Groundwater Application Review Summary Form

Application # G- 19428

TO: Water Rights Section Date 6/18/2025
 FROM: Groundwater Section James Hootsmans
 Reviewer's Name
 SUBJECT: Application G- 19428 Supersedes review of _____
 Date of Review(s)

A. GENERAL INFORMATION: Applicant's Name: Warren and Jody Haury County: Marion

Well Statistics for All Wells – Sections 30 - 32

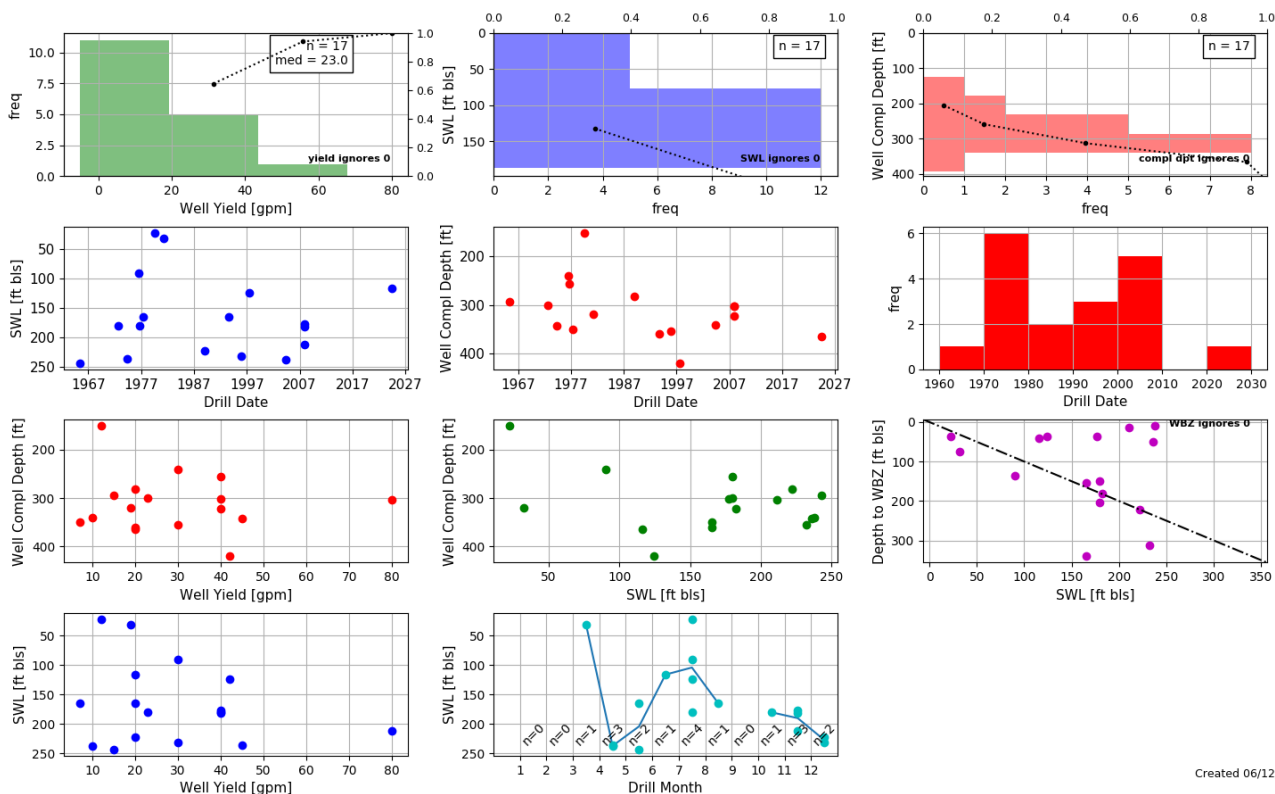
Well statistics for nearby irrigation and domestic wells in Sections 30, 31 and 32 for alluvial and basalt wells indicate that the maximum well yield is less than 70 gpm. The proposed rate for the proposed POA is 1.48 cfs (approximately 660 gpm) which is almost 9.5x the maximum yield of wells in the area. Limiting the data to only wells deeper than 150 feet below ground surface (bgs), about 50 to 70 feet into basalt, the median well yield is 23 gpm and the maximum is also less than 70 gpm. Therefore, it is unlikely that the requested rate will be within the capacity of the resource.
